SERVICE BULLETIN

SB1245

ADDRESSEES	: Owners and operators of coaches listed under 'Application'
VEHICLE MODEL	: TD925
SYSTEM/SUBSYSTEM	: Body and accessories – driver's seat
BULLETIN TYPE	: Safety Recall Program – NHTSA campaign ID number 12V-323
DATE	: September 13 th , 2012
SUBJECT	: Driver's seat anchorage assembly – Replacement of riser and floor adapter plate
TERMS & CONDITIONS	: Refer to the warranty section further in this Bulletin.

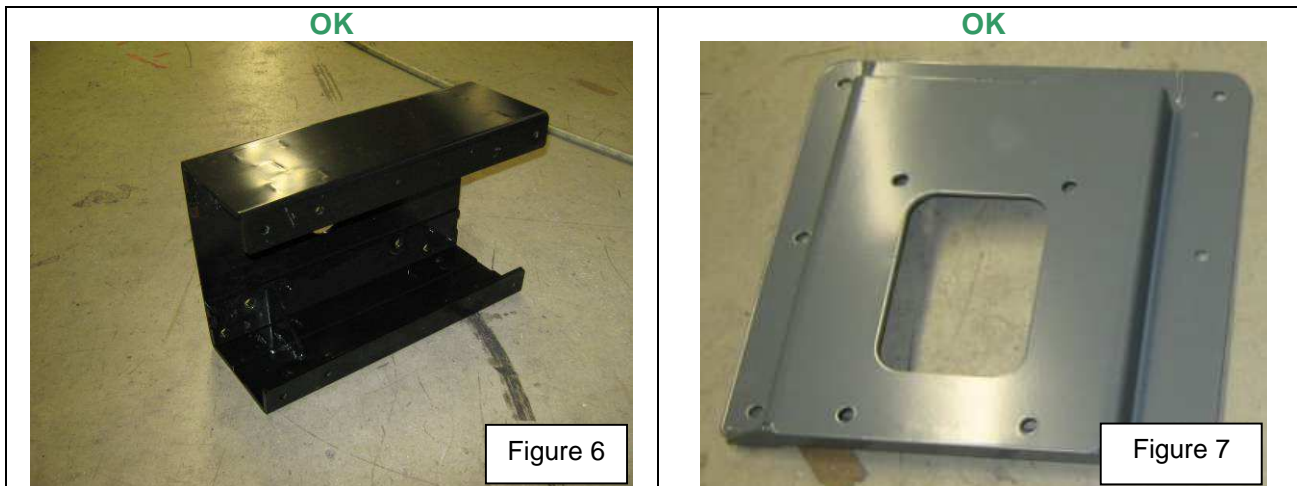
Noncompliant parts: ISRI riser, ISRI adapter plate, Van Hool floor adapter plate and fixation material (Figure 2, 3, 4 and 5)

VH reference	Description of noncompliant parts	Qty.	Refer to
11307654	ISRI riser	1	Figure 2
10672095	ISRI adapter plate	1	Figure 3
11134267	Van Hool floor adapter plate	1	Figure 4
660224503	Screw, M10 x 1.50 x 30, grade 8.8, DIN933	6	Figure 5

Compliant parts: ISRI riser, Van Hool floor adapter plate and fixation material (Figures 6 and 7)

VH reference	Description of compliant parts	Qty.	Refer to
11319711	ISRI riser	1	Figure 6
11320020	Van Hool floor adapter plate	1	Figure 7
660222404	Screw, M8 x 1.25 x 25, grade 10.9, DIN 933	6	
660207116	Nut, self-locking, M8, DIN 985	6	
660226606	Screw, M12 x 1.75 x 35, grade 10.9, DIN 933	4	
660629103	Washer, flat, M12, 13 x 24 x 2.5 mm, DIN125	4	
660207404	Nut, self-locking, M12, DIN 985	4	
11149701	Screw, M10 x 1.50 x 30, grade 10.9, DIN933	6

Figure 33

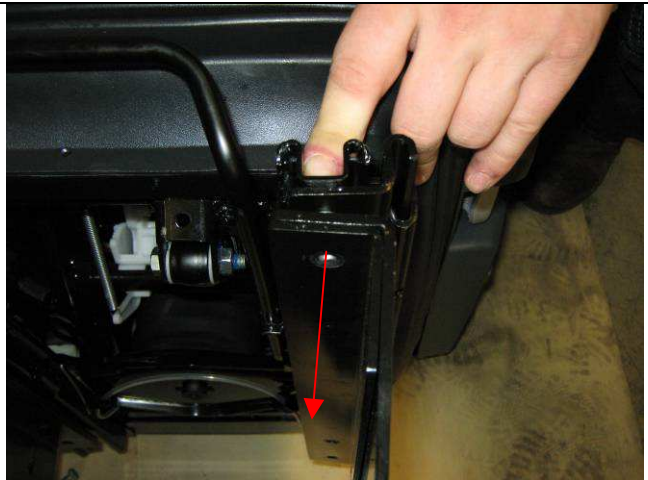
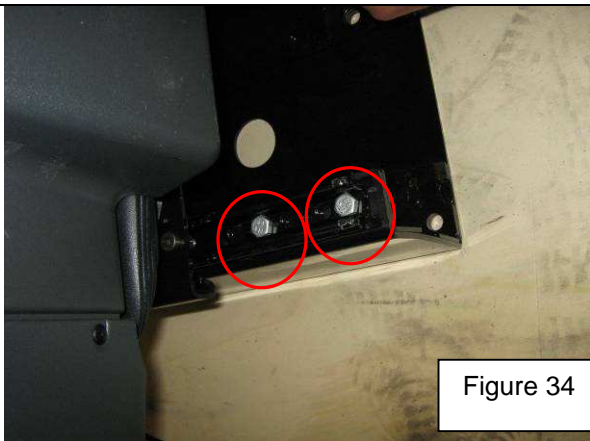
Secure the sliders and metal plates to the compliant riser (VH 11319711). Use two M8x25 grade 10.9 screws (VH 660222404) and two M8 nuts (VH 660207116) (two sides).

Move the driver's seat to the most forward position and secure the sliders and metal plates to the compliant riser. Use four M8x25 grade 10.9 screws (VH 660222404) and four M8 nuts (VH 660207116) (two sides).

Check all six bolt with a torque wrench. Tightening torque: 25 ± 3.75 Nm (19 ± 2.75 ft.lbf)
